May 2018
INT FL766-01
NHTSA #18V-191
Transport Canada #18-190
INTERIM RECALL BULLETIN

Subject: Western Star Power Cable Studs

Models Affected: Specific Western Star 4700, 4900, 5700, and 6900 model vehicles manufactured September 12, 2016, through February 6, 2018.

Fig. 3, Installation Inspection

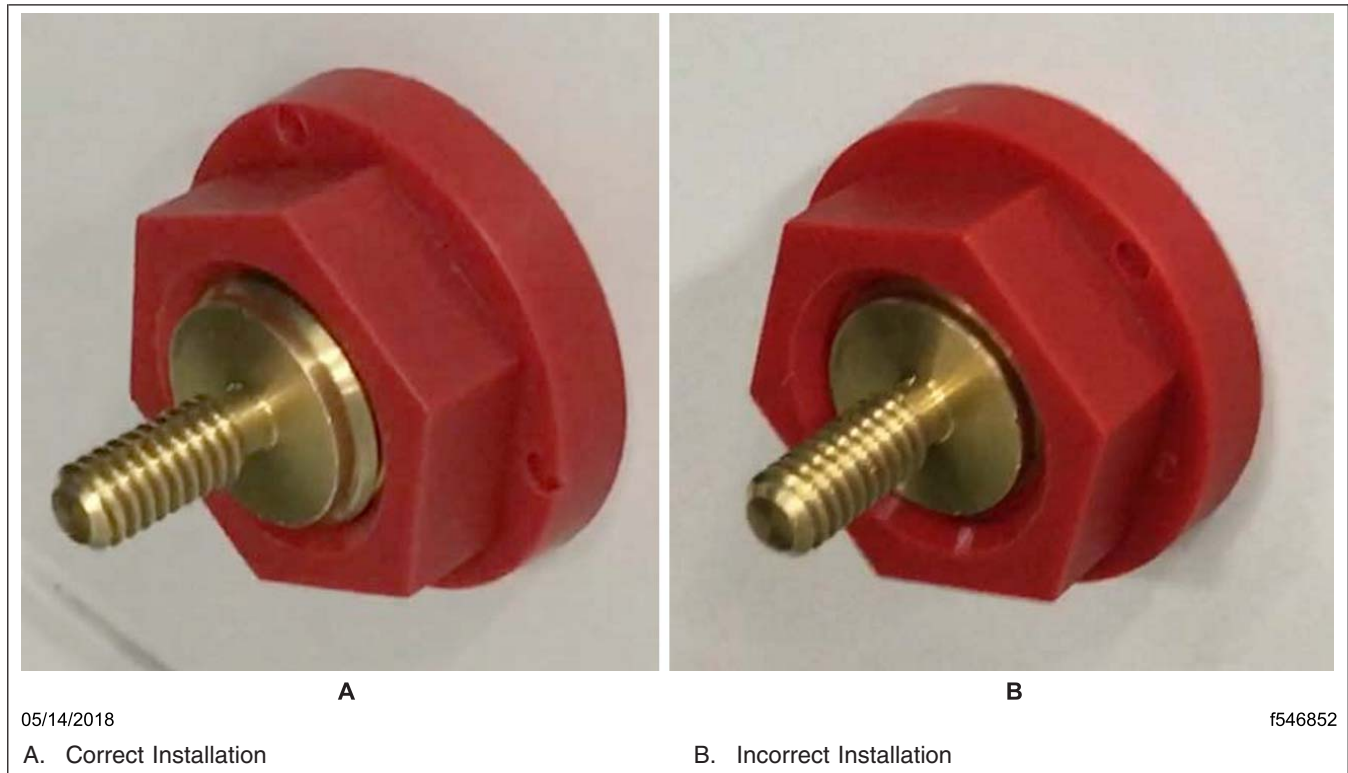
1. Check OWL prior to performing the interim recall to ensure the vehicle is involved and the campaign has not been previously completed. **DO NOT** use a completion sticker for the interim inspection or repair. Attaching a recall completion sticker may prevent the customer from getting the final recall repair.
2. Park the vehicle on a level surface, shut down the engine, and set the parking brake. Chock the tires.
3. Open the hood and locate the three battery bulkhead connectors on the front wall. See [Fig. 1](#).
4. Pull back the covers on the battery bulkhead connectors. See [Fig. 2](#). Inspect the bulkhead studs to make sure at least one thread protrudes past the plastic nut. See [Fig. 3](#) and [Fig. 4](#).

If at least one thread does NOT protrude past the plastic nut, the installation is INCORRECT. Proceed to the next step.

*If at least one thread protrudes past the plastic nut, the installation is CORRECT and the recall is complete. Install the connector covers. **DO NOT** use a completion sticker for the interim inspection or repair. Attaching a recall completion sticker may prevent the customer from getting the final recall repair.*

Fig. 5, Location of Front-Wall Power Terminals (inside the cab)

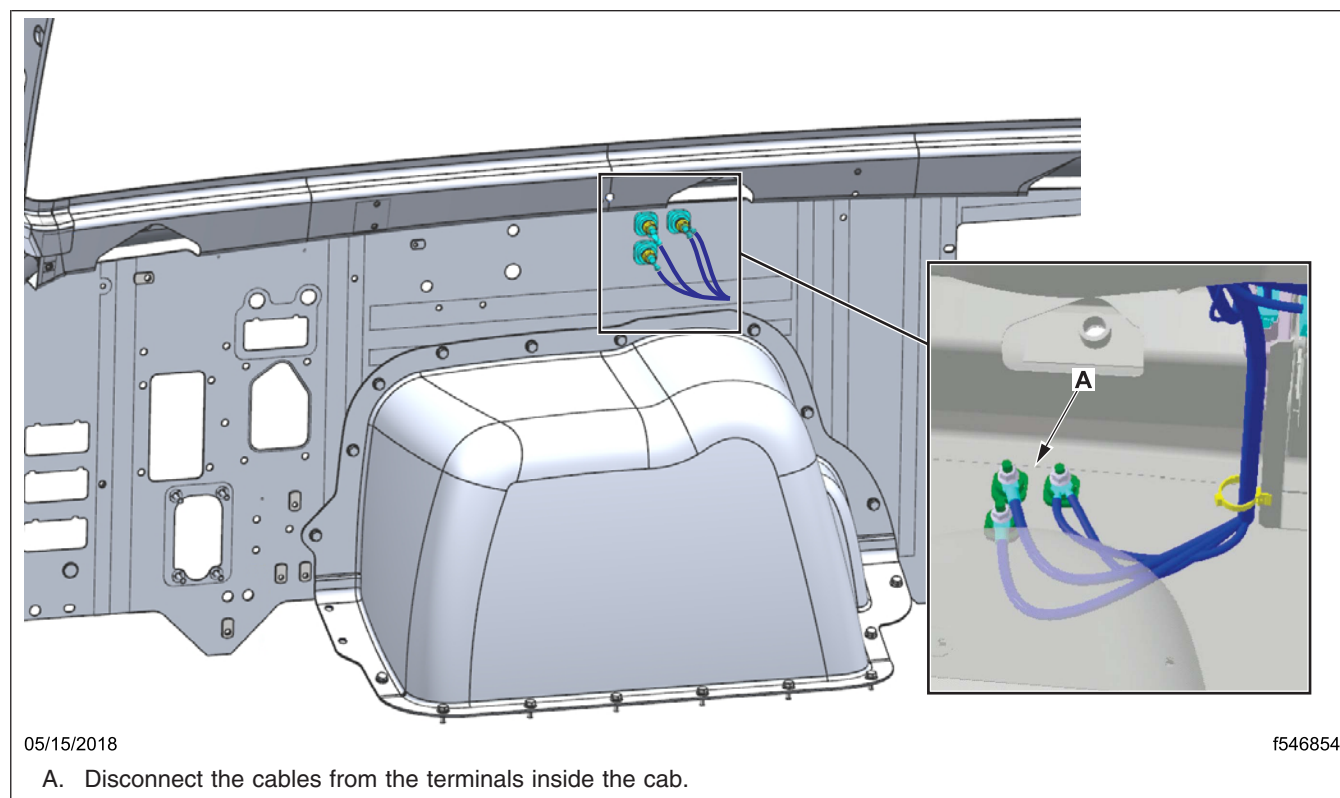
7. Disconnect the cables from the terminals inside the cab. See **Fig. 5**

8. Disconnect the cables from the terminals on the outside of the front wall.
9. Remove the plastic nuts and the studs.
10. Check the gaskets for damage. Replace damaged gaskets.
11. Fully seat the stud in the square hole.
12. Tighten the plastic nut 60 to 84 lbf·in (680 to 950 N·cm). Make sure at least one thread is exposed past the plastic nut.
13. Connect the cables to the terminals on the outside of the front wall.
14. Connect the cables to the terminals inside the cab.
15. Install the dash. Refer to the *Western Star Workshop Manual*, **Section 60.06, Subject 110**.
16. Once the interim repair is complete, **DO NOT** attach a completion sticker. Attaching a completion sticker may prevent the customer from getting the final recall repair.
